PCN #: 2799

PCN Title: Qualification of Internal "Diodes Technology (Cheng Du) Company Limited" (CAT) with Standardization of Assembly Bill of Materials and Change of Lead Frame Type as well as Die Attach Epoxy Type at Currently Qualified A/T Site (CAT) for Select Discrete Products.

PRODUCT CHANGE NOTICE

PCN-2799-REV1

Table 5: Part Marking Format for Affected Parts in Table 1 –

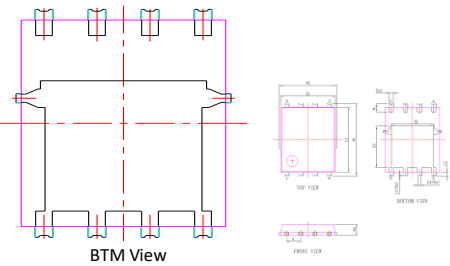
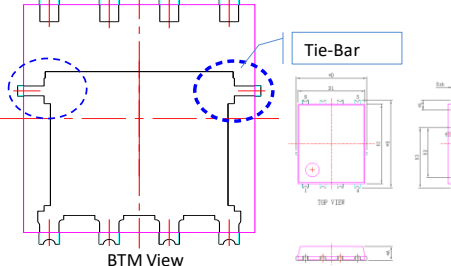
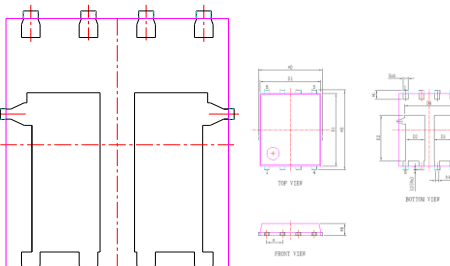
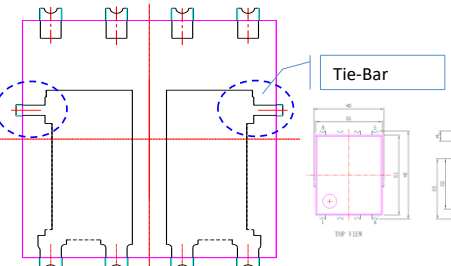
Package	SAT (Baseline) (Diodes Internal A/T Site - Shanghai, China)	CAT (Change) (Diodes Internal A/T Site - Chengdu, China)
	No bar on Date Code	Add bar "-" above YY (Year) of Date Code
SWP-PowerDI5060-8L R/Q	Marking Format Example: 	Marking Format Example:
